SERVICE BULLETIN

SB-073018 REV B

DATE ISSUED: 7/31/2018
DATE EFFECTIVE: 7/30/2018
SUPERSEDES NOTICE: SB-073018-A.
SUBJECT: MSC Software Upgrade Version 3.0

REQUIRED ACTION: Upgrade MSC software version to 3.0 (PN: ICA010570 Rev D)

Figure 2: MSC Unit

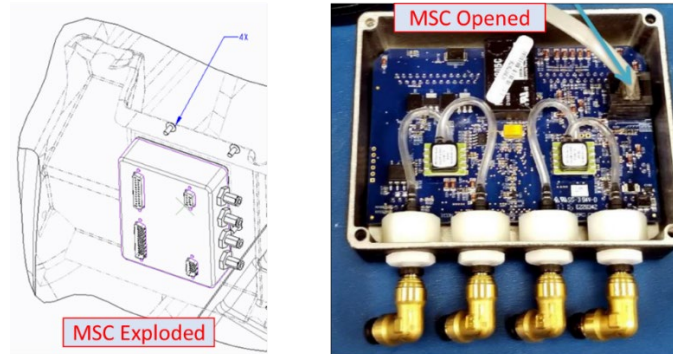
1. Remove existing DAC unit in accordance with Maintenance Manual and set aside.
2. Remove existing MSC unit in accordance with Maintenance Manual.
3. Remove 4 screws from the back of the MSC panel and set aside and retain hardware for re-install, Figure 2.

Figure 3: Software Screen

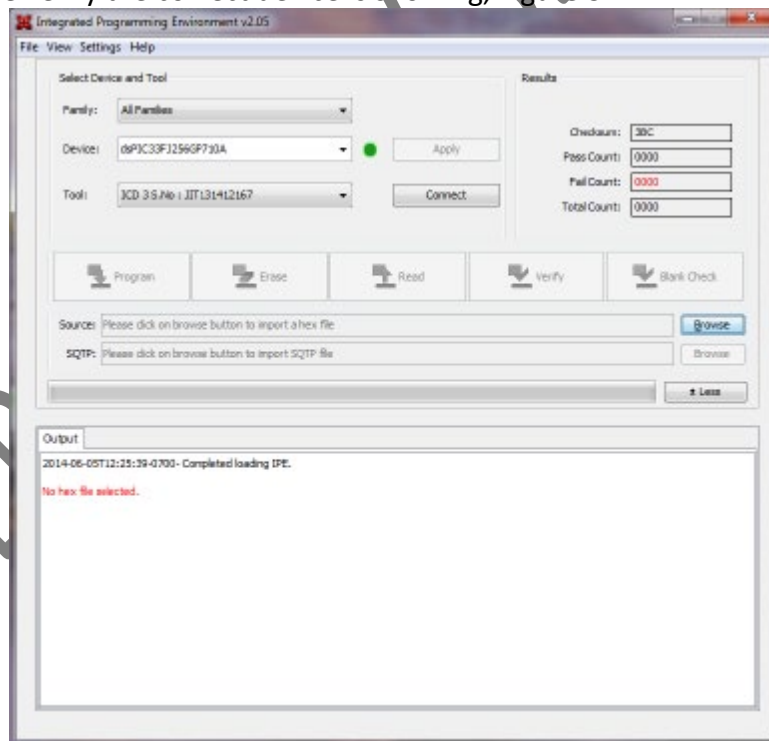
4. Open MPLAB IPE v 3.55 on the computer.
5. Connect Serial Power Port to the back of the MSC.
6. Turn on Pyramid Power Supply.
7. Connect USB cable from MPLAB DV164035 to the computer.
8. Connect ethernet cable from MPLAB DV164035 to the inside of the opened MSC.
9. Select the device under the Device dropdown to: **dsPIC33FJ256GP710A**. If selecting for the first time otherwise verify the correct device is showing, Figure 3.

Figure 4: Connecting to MSC

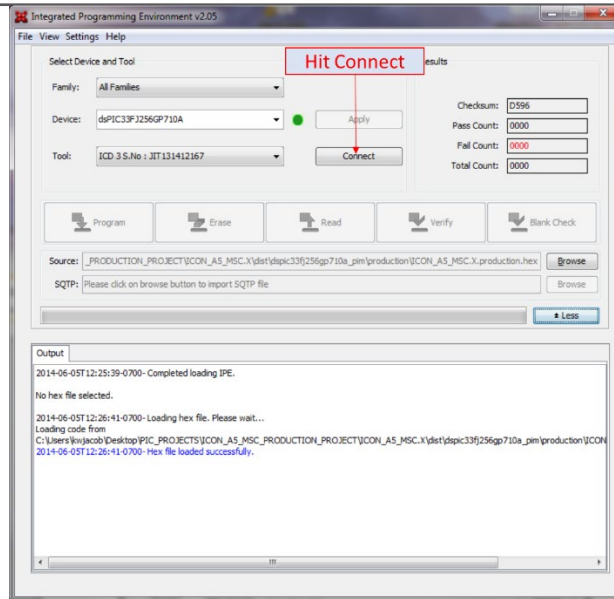
10. Hit Connect as shown in Figure 4 to connect software to the MSC.

Figure 5: Open Dialog Reference

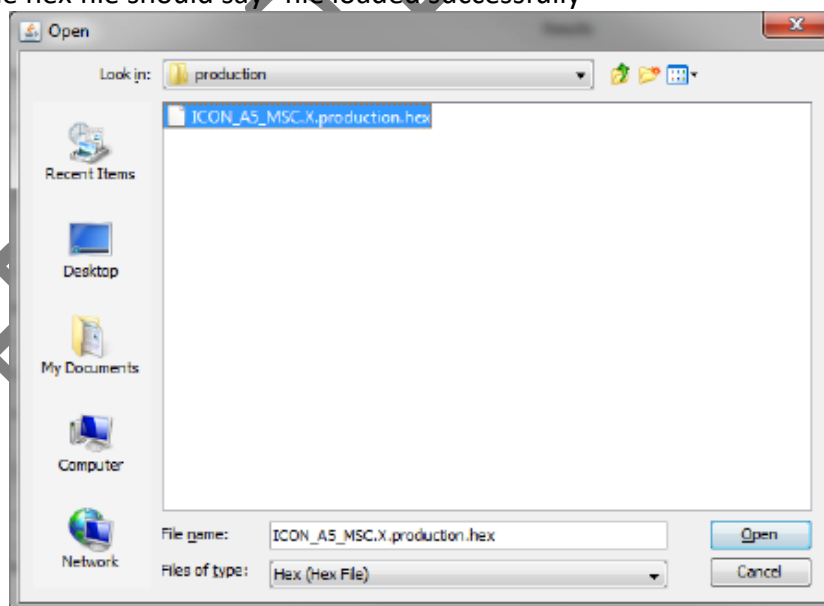
11. Using the browse button, select the .HEX file supplied for your software version. The following dialog will open, allowing you to point to the .HEX file, Figure 5 and Figure 6.
12. Use provided file labeled “ICON_A5_MSC_V3_0_RELEASE.X.production.hex”
13. Once the file has been opened, status show indicating that the file has been loaded as shown in Figure 7. The hex file should say “file loaded successfully”

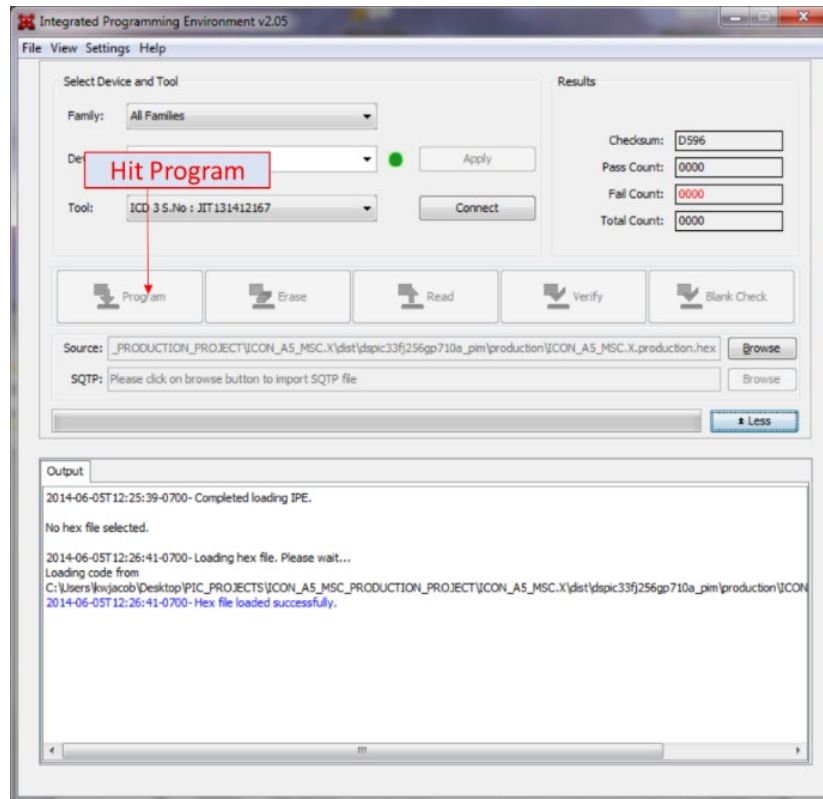
14. Hit Program, the MSC should program properly at this point. It will automatically reset and start the new code when it is done. The program will indicate status success once the hex is loaded onto MSC, Figure 7.
